Report

for Oct 2021 – 1st MP

BFX – UA300

Date : 22-Oct-2021
Prepared by: Heng Ruan

4. Factory stuff inside the product

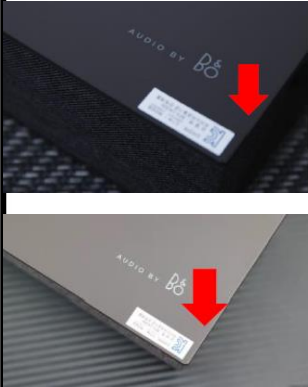
Issue Description	Root Cause	Actions	Owner	Due Date	Status
Factory stuff inside the product Type: Minor 1pcs / 756pcs SET temp label on the rear side 2pcs / 756pcs Defect rate : 0.39%  	1. At printer device label station , after scan MAC on draft label to purpose of device housing label printing, operator must remover draft label (just factory control and use for function test before links product with KSB SN). But operator was forget remover this label and take pass product to next station. 2. OP at Visual Inspection check cosmetic product was not defect and remove this label 3. OP did memo on RCU have remark “ RCU NG ” cause OP defect visual inspection RCU defect PE bag broken. So OP write remark for line leader know. But he put NG and OK accessory together in same box. In next shift OP doing at this station don't know and put this RCU normal user. 4. After close gift box there are only OBA station can check accessories inside but it's only random check with sample rate C=0, AQL=0.4.	1. Training all OP by Quality alert customer high light inspection issue with K18 product.  Factory Stuff Inside Training 2. Add an NG material area where all NG material must be put on after separate out of production line. 3. Increase OBA sample rate by C=0, AQL=0.25	PQE: Bien IE: Hang PD: Van Anh	Done 22-Aug
